Re: FOUNDRY Recreation Center and Neighborhood Park (Application DA-2315-02; Case 2024-4003-00)

Technical Submission Review

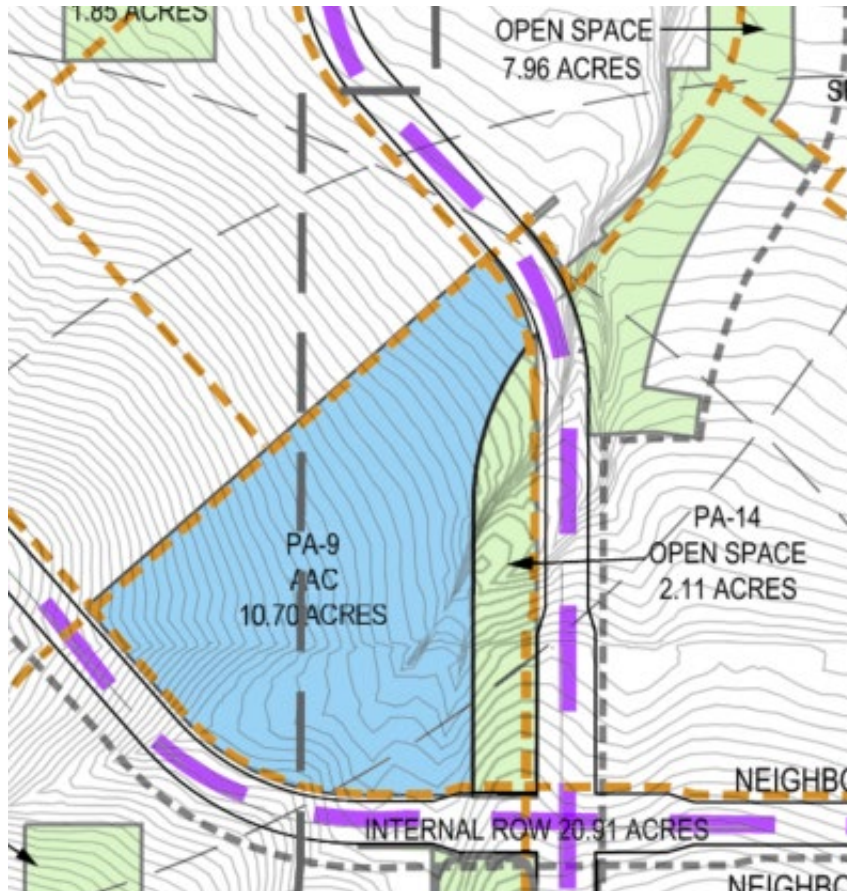
- c. Ensure all easements meet the requirements listed in Section 5.04.

Response: The easements meet the minimum requirements listed in section 5.04. Specifically the water utility has a 10' easement around the center and a 10' distance between the sanitary line running next to it. These utilities also meet the vertical distance which will be described in the CD submittal.
